May 13, 2021

I would like to specifically focus on improving the Bikes May Use Full Lane message in sign R4-11. That sign is almost always used sparsely along the side of the road in conjunction with shared lane markings (sharrows) in a travel lane. Informal polling of road users, including some city planners, indicates that these signs are not noticed; some even exclaim “I never even saw that sign before.” That is largely due to drivers paying more attention to the roadway in front of them. These signs are small and pass by in a fleeting moment on the side of the road, often far right of where sharrows are placed.

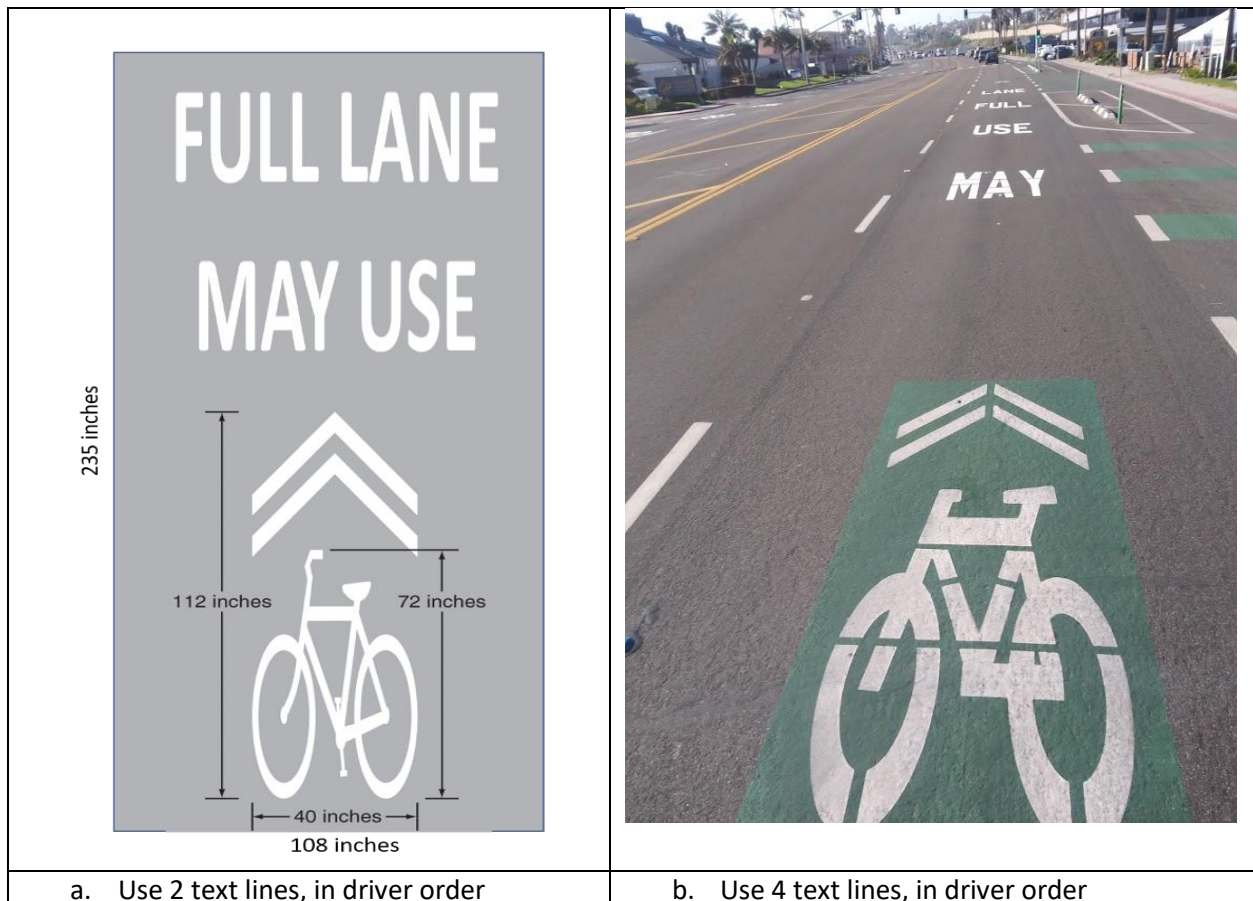
I would like to recommend that, where one might normally place a R4-11 sign on the side of the road, that a sharrow at strategic points be accompanied by the R4-11 words on the pavement. There are a couple of possibilities:

I would leave it to someone with Traffic Engineering expertise to determine the correct dimensions, spacing and the stretching of the letters for optimal readability as motorists drive over this augmented sharrow.

The second option (b.) in the figure has been recently implemented on a stretch of Hwy 101 in Encinitas, CA by Abe Bandegan, Traffic Engineer for the city of Encinitas, CA. [Click here for a video](#) of what that looks like from a motorist point of view driving at 35 mph.
